CITY OF CAMBRIDGE
BUILDING DIVISION

WILLOW 2 (GR)
ELEVATION 1, 2 & 3

TITLE SHEET
BARLASSINA CONSTRUCTION
CITY OF CAMBRIDGE

MODEL:	WILLOW 2	
	SCALE:	3/16"= 1'-0"	
	PROJ. No.	21-35	DWG. No.
			0

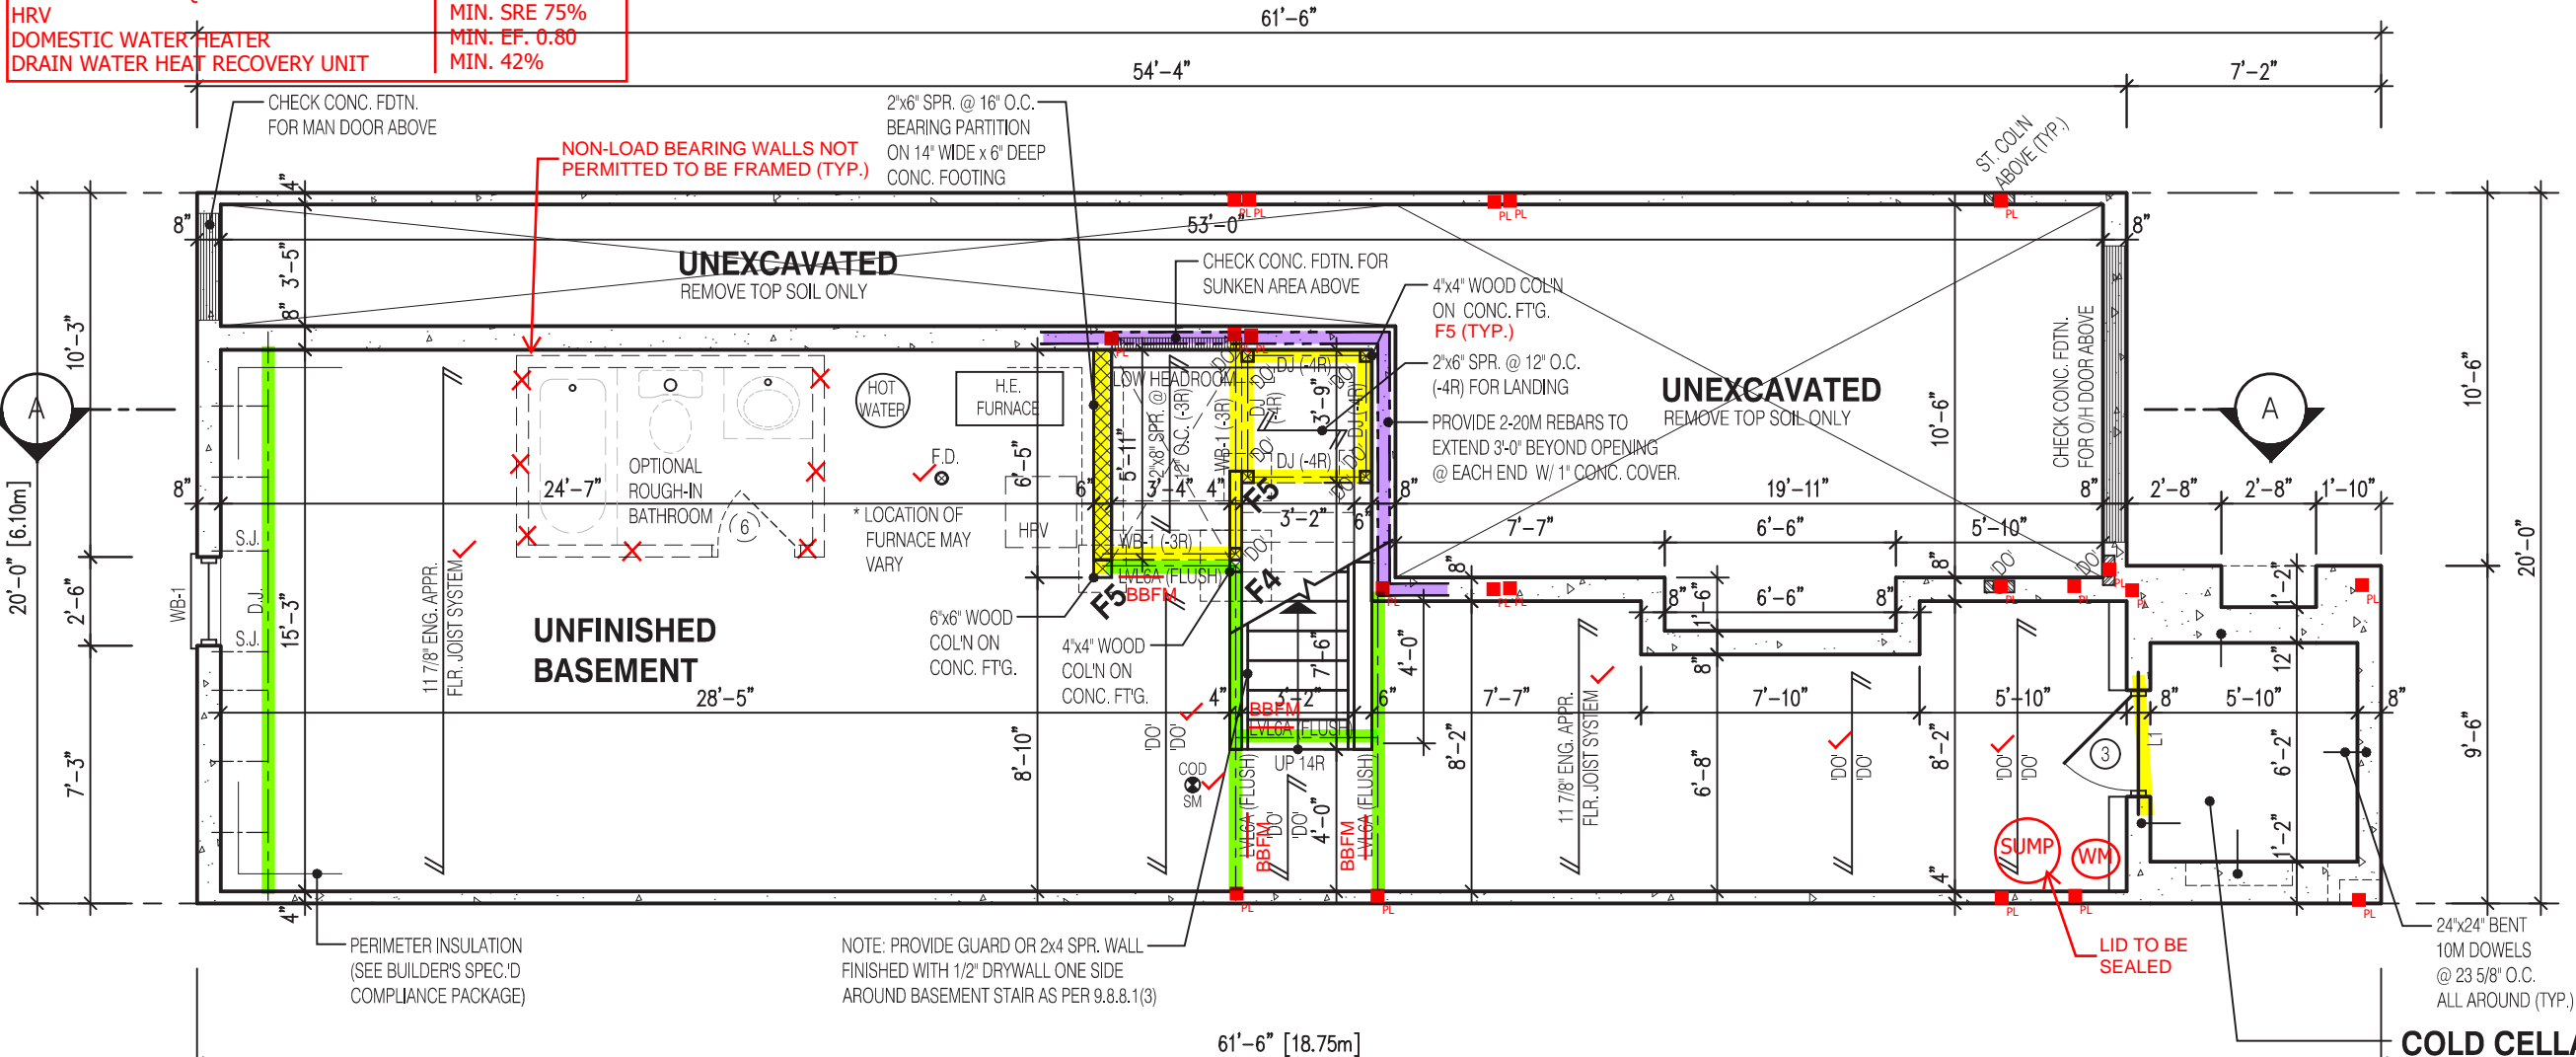
PROVIDE P.ENG APPROVED TRUSS & FLOOR DRAWINGS AND SPECIFICATIONS TO BUILDING INSPECTOR AT FRAMING INSPECTION

INSTALLATION OF FLUSH STEEL BEAMS SHALL CONFORM TO THE REQUIREMENTS OF 9.23.9.2.(3), (4) & (5)

P.ENG SOILS REPORT MAY BE REQ'D TO CONFIRM BEARING CAPACITY OF SOILS. SEE FIELD INSPECTOR

FINAL GRADING CERTIFICATE REQ'D BEFORE FINAL INSPECTION SIGN-OFF

ENERGY PERFORMANCE LABELS FOR ALL GLAZING PRODUCTS IDENTIFYING THE CERTIFIED VALUES SHALL REMAIN ON FOR REVIEW DURING CONSTRUCTION

REINFORCING REQUIRED IN FOUNDATION WALL OR PORCH SLAB SHALL BE REVIEWED PRIOR TO POURING CONCRETE (see inspector)

A SEPARATE PERMIT IS REQUIRED FOR THE FINISHING OF ALL ROUGHIN PLUMBING FIXTURES

A CARBON MONOXIDE DETECTOR SHALL BE LOCATED ADJACENT TO SLEEPING AREAS

THE ONTARIO BUILDING CODE REQUIRES THAT A SMOKE ALARM BE INSTALLED ON EACH FLOOR LEVEL AND WITHIN EACH SLEEPING ROOM. ALL SMOKE ALARMS SHALL BE INTERCONNECTED. EACH DEVICE SHALL HAVE A VISUAL SIGNALING COMPONENT IN ADDITION TO THE TEMPORAL PATTERN IN CONFORMANCE WITH 18.5.3. OF "LIGHT, COLOUR AND PULSE CHARACTERISTICS" OF NFPA 72

ALL NEW WINDOWS AND SLIDING GLASS DOORS TO COMPLY WITH THE THERMAL REQUIREMENTS OF SB-12. MAX U-1.6, ER-25

FLOORING IN KITCHENS, WASHROOMS, LAUNDRY, AND STORAGE AREAS, SHALL CONSIST OF FELT-SYNTHETIC-FIBRE FLOOR COVERING, CONCRETE, TILE, OR OTHER FLOORING PROVIDING A SIMILAR WATER RESISTANCE.

MAX. HOT WATER TEMP. SHALL NOT EXCEED 49°C (120°F) EXCEPT FOR DISHWASHERS AND CLOTHES WASHERS

SIDING MATERIALS SHALL CONFORM TO SECTION 9.2.7 OF DIVISION B OR HAVE A CIVIC OR BMEC APPROVAL, OR A MINISTERS RULING

BASEMENT PLAN EL-1
BARLASSINA CONSTRUCTION
CITY OF CAMBRIDGE

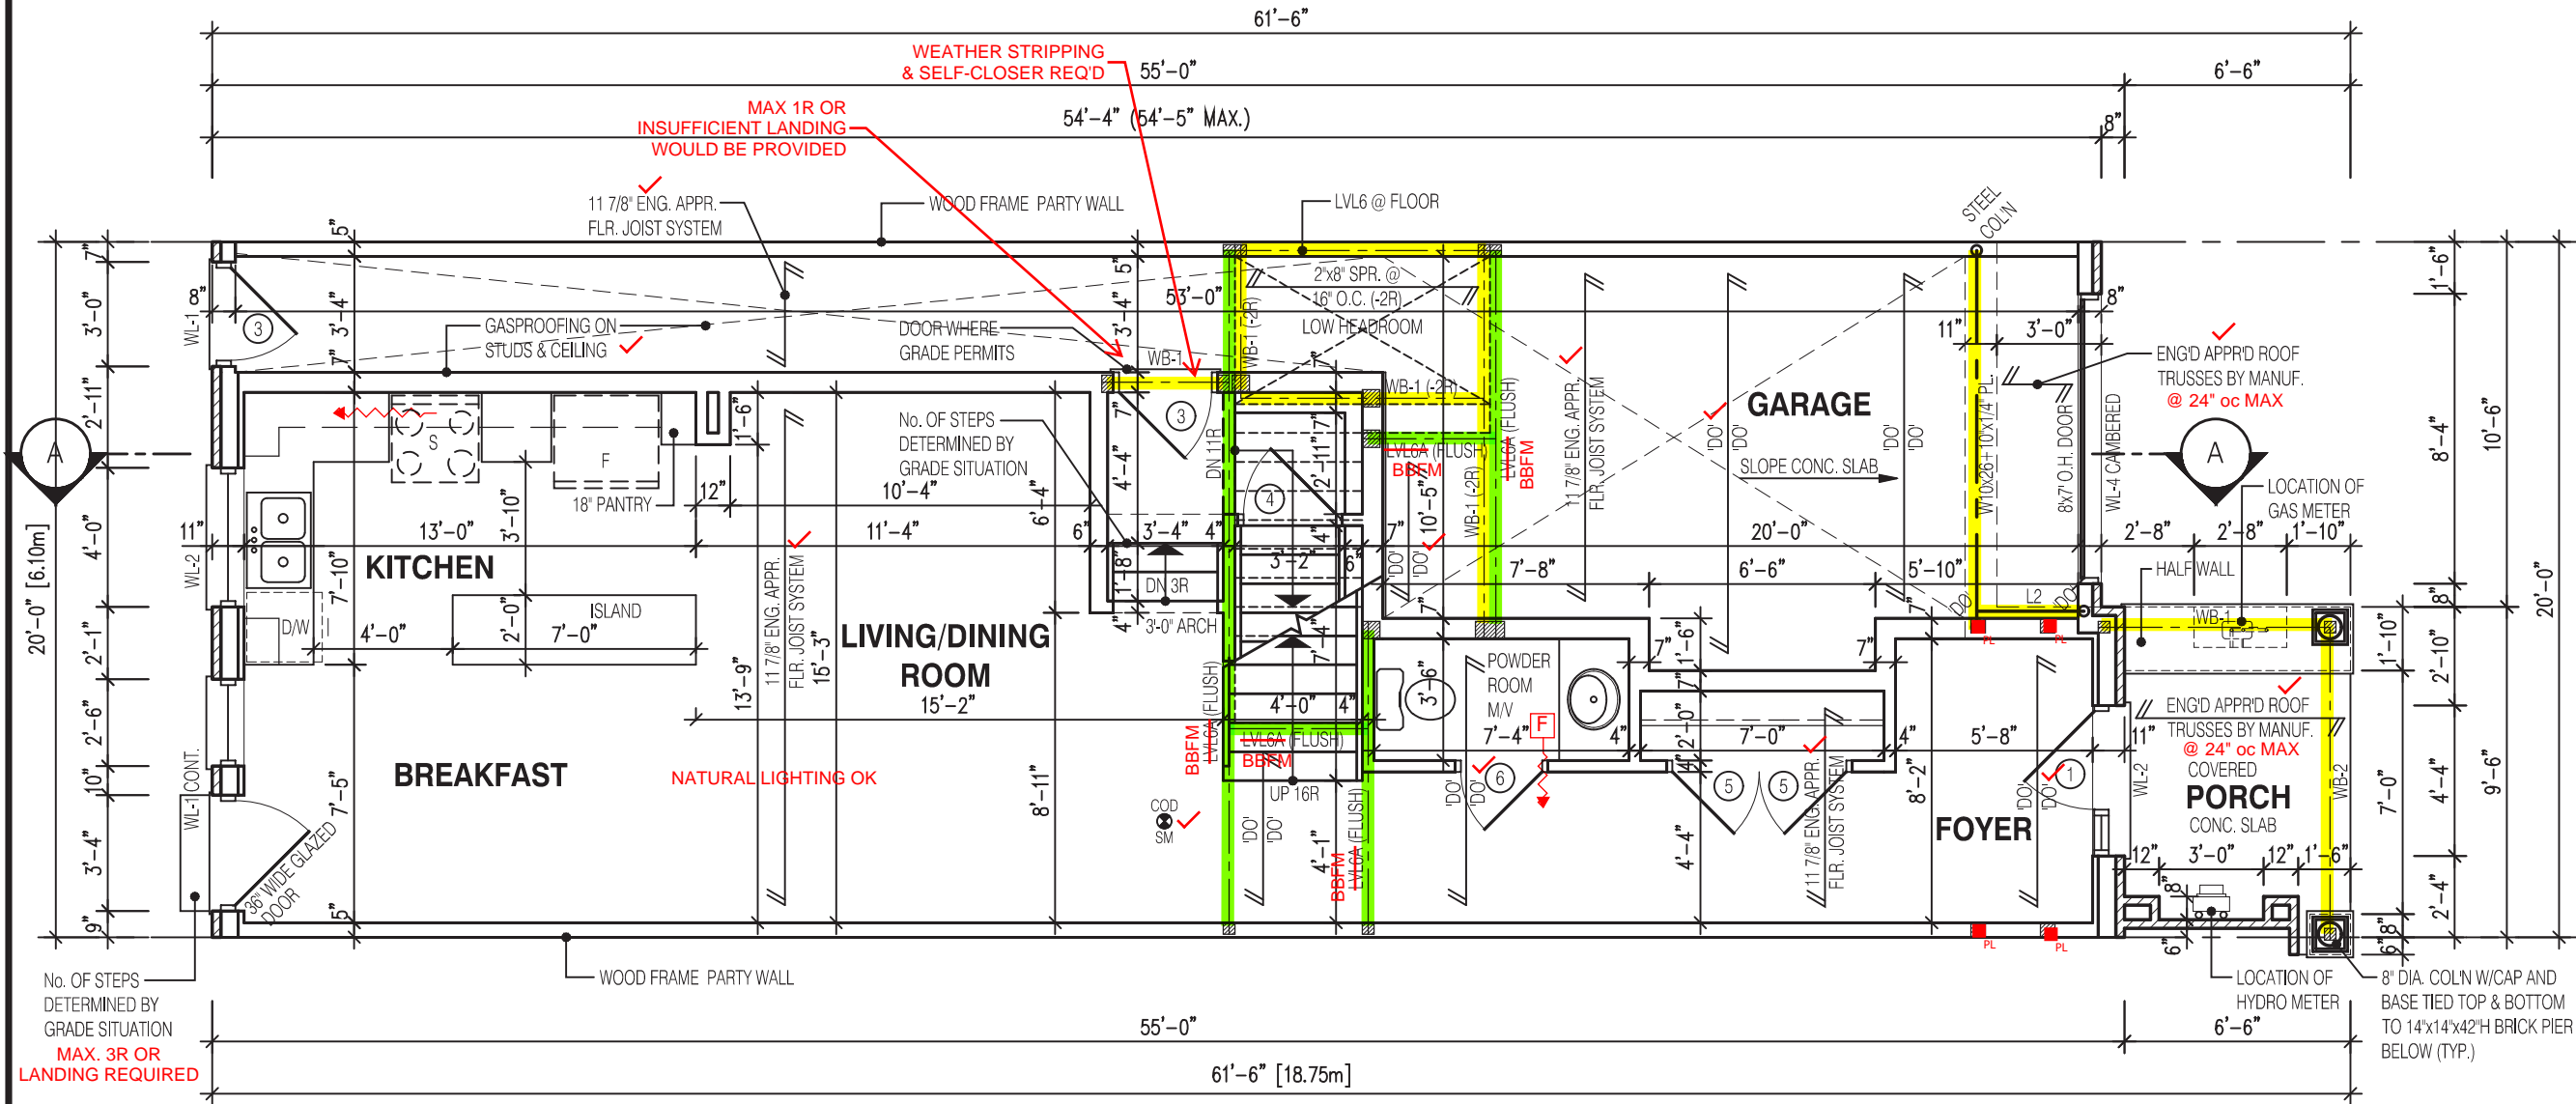
VERIFY WATER METER AND DWHR
UNIT LOCATION WITH INSPECTOR

SPRAY FOAM/RIGID INSULATION TO BE
PROTECTED AS PER 9.10.17.10.(1)

WATER METER TO BE INSTALLED WITHIN 2m
(6'-6") FROM THE POINT THE WATER SERVICE
PIPE MEETS THE BUILDING LINE

REQUIRED CONTINUOUS INSULATION
CANNOT BE INTERRUPTED BY FRAMING
MEMBERS SUCH AS STUDS
